Considerations for MTF Specification Comments against D2P0

Sam Kocsis, Hansel D'Silva Amphenol

Joint Ad-hoc 250605

Comparison of Measurement Bandwidth

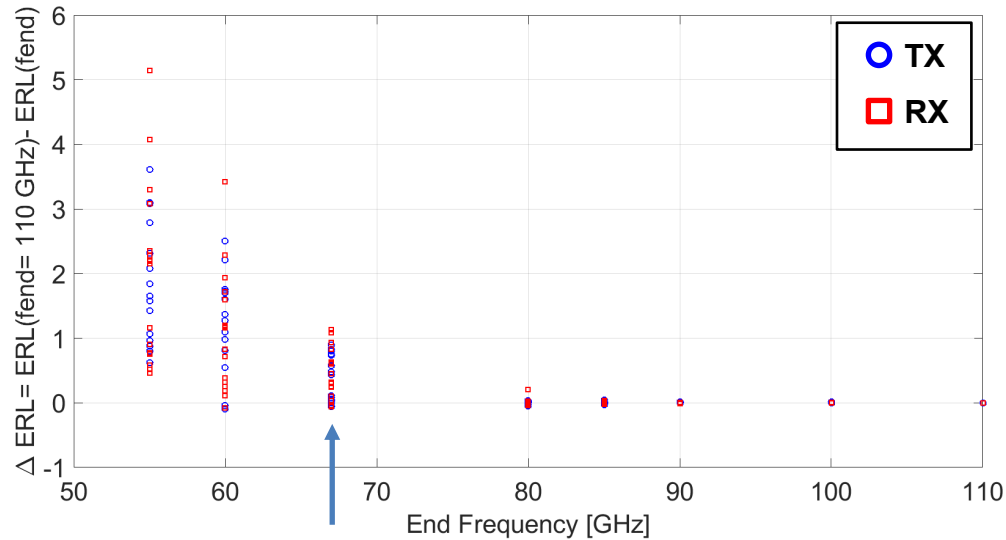
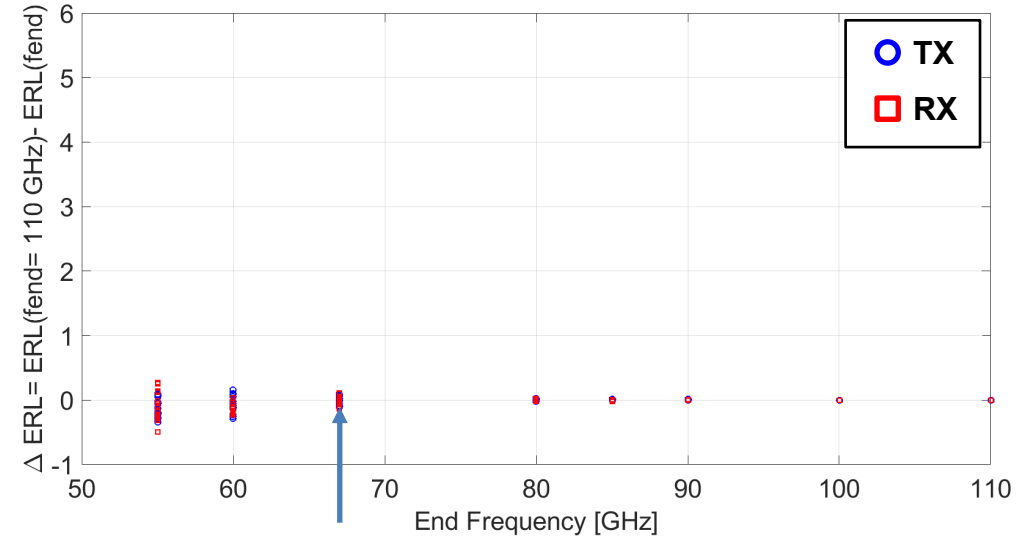
67 GHz

Min: -0.0633

Max: +1.1299

67 GHz

Min: -0.1364

Max: +0.1068

- Target goal is a small ΔERL (±0.1 dB) between 67 GHz and 110 GHz measurements

Comparison of Measurement Bandwidth

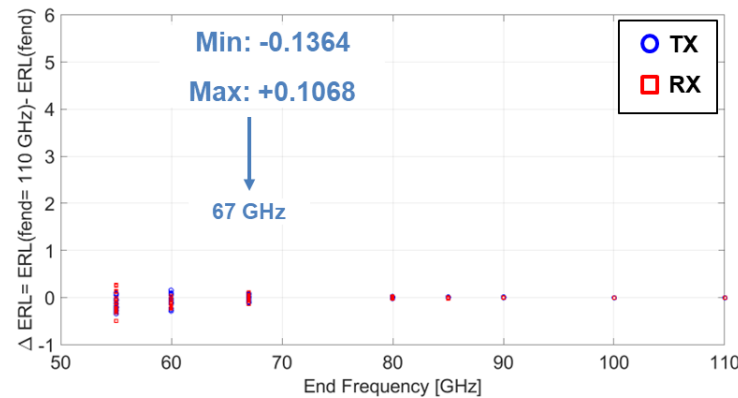
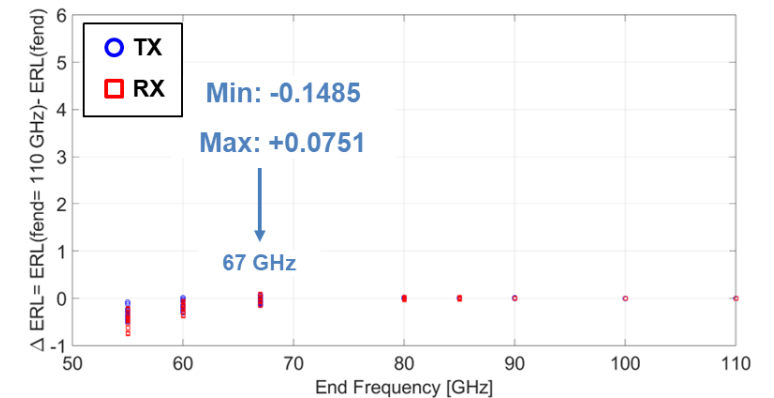
COM v4.9*

kocsis_01b_2505

Proposal

- Recommended is the zero-padding based extrapolation for the high frequency
- The change in the COM tool will need to be done in considering both COM and ERL

Impact of Reference Impedance on ERL

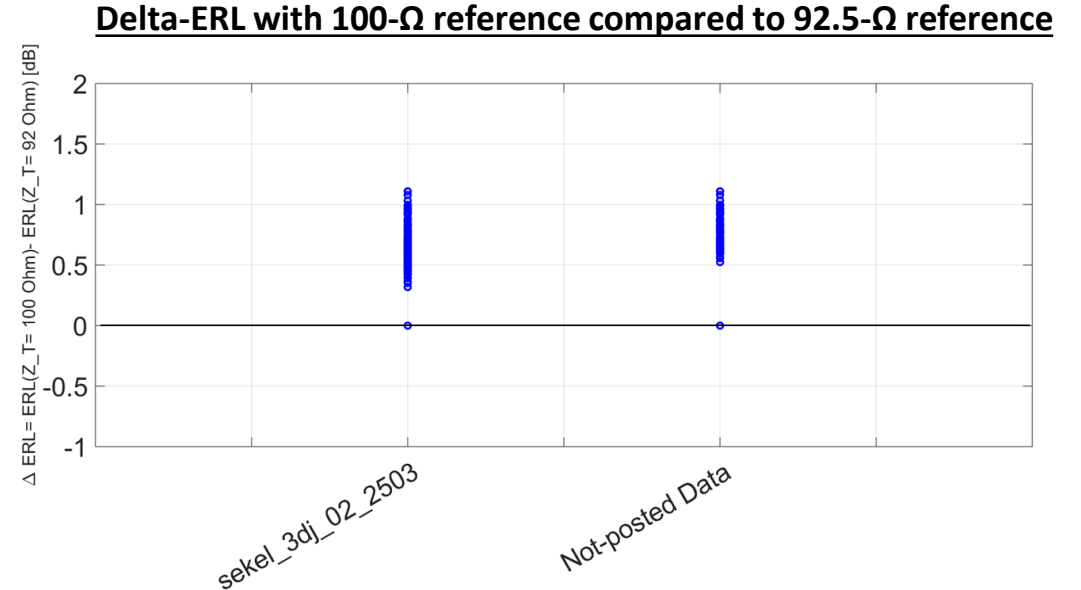
- “Not-posted Data” includes a collection of different, but similar MTF data
 - Takeaway point: The observed impact is not expected to be unique to the posted 3dj MTF measurement data
- ERL computations with a reference impedance of 92.5-Ω have an observable penalty of ~1dB

- Propose implementing zero-padding based high-frequency extrapolation
 - Promote the method as default setting in future COM release
 - Promote changes with commit request to COM ad-hoc
- Only Annex179B requires an ERL computation of 92.5- Ω
 - Posted data suggests test fixtures will be designed with a bias towards test and measurement equipment and results will be calibrated with a 100- Ω reference
 - Align computation method in Annex179B with all other Clauses in 802.3dj
